Butler Subdivision

Butler Subdivision
PART OF THE NW 1/4 OF SECTION 32, T.6N., R.2W., S.L.B & M., U.S. SURVEY
WEBER COUNTY, UTAH

Preliminary Design

STREET SECTION (50' R.O.W.) PRIVATE ROAD

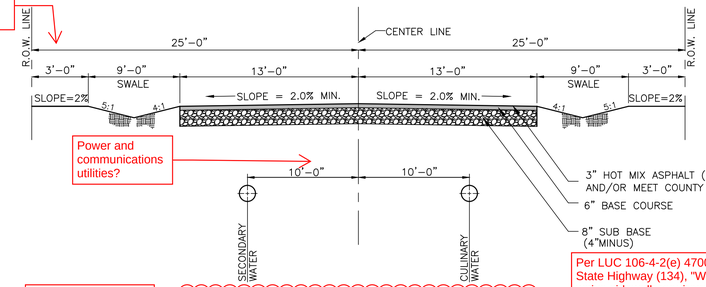
Power and communications utilities?

Per LUC 106-2-2 (c) This ROW will need to be increased to 60' to accommodate for a standard residential public street.

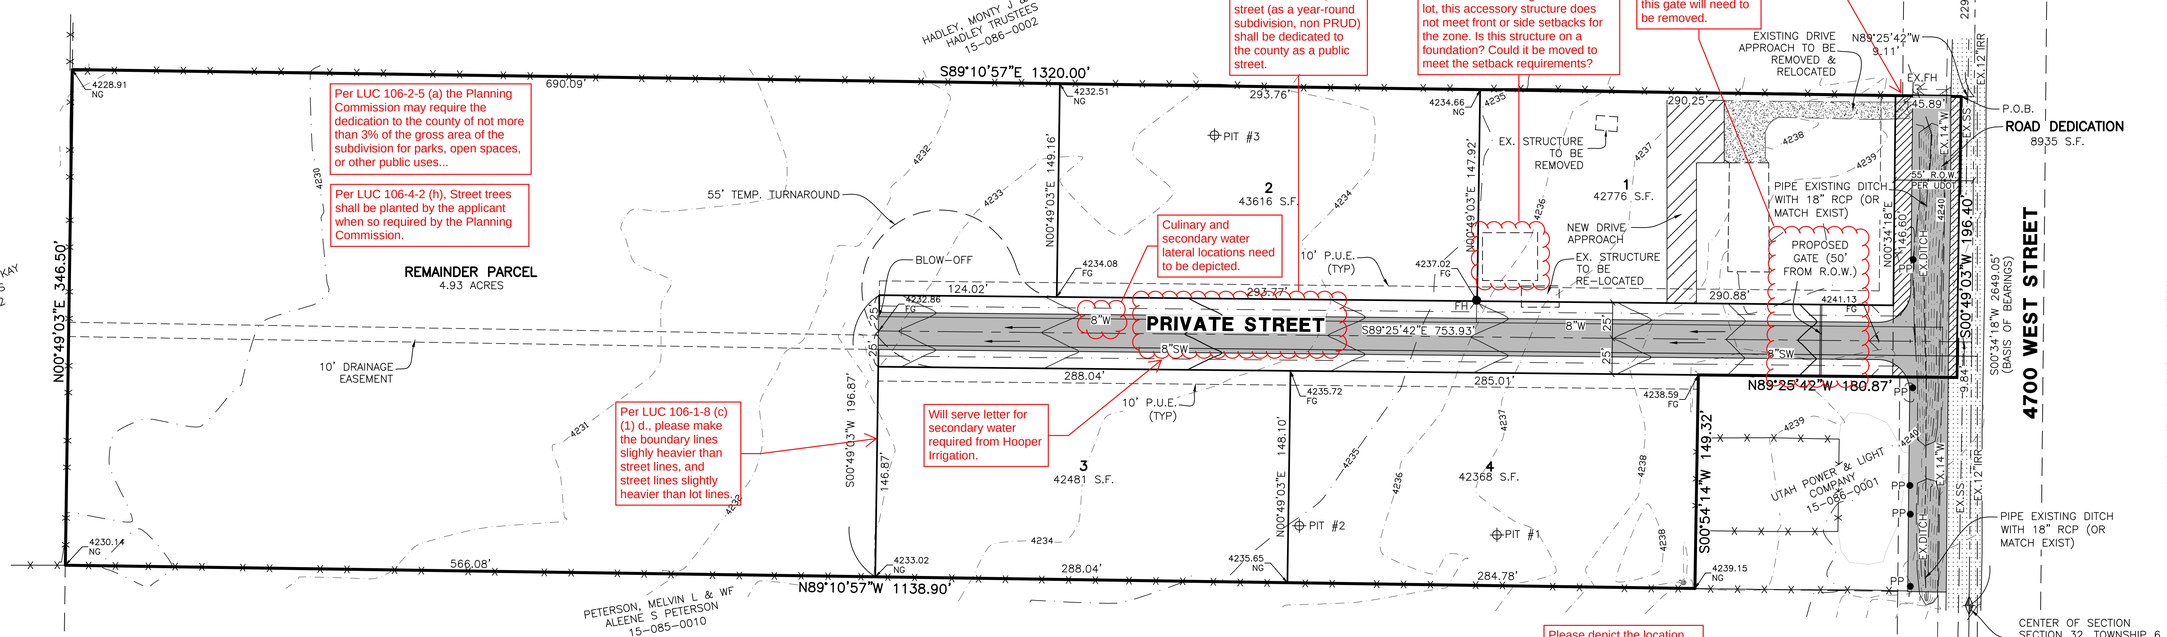
Per LUC 106-4-2(e) 4700 W. is classified as a State Highway (134), "Weber County will not waive sidewalk requirements on state highways unless the Utah State Department of Transportation has waived the sidewalk requirement. If a letter is provided by UDOT for a waiver, then a deferral agreement may be approved by the county commission.

Per LUC 106-2-2, This street (as a year-round subdivision, non PRUD) shall be dedicated to the county as a public street.

Under the new configuration of this lot, this accessory structure does not meet front or side setbacks for the zone. Is this structure on a foundation? Could it be moved to meet the setback requirements?

As a public street, this gate will need to be removed.

Please depict the location and nature of all easements listed within the title report. Please include each easement's entry #.
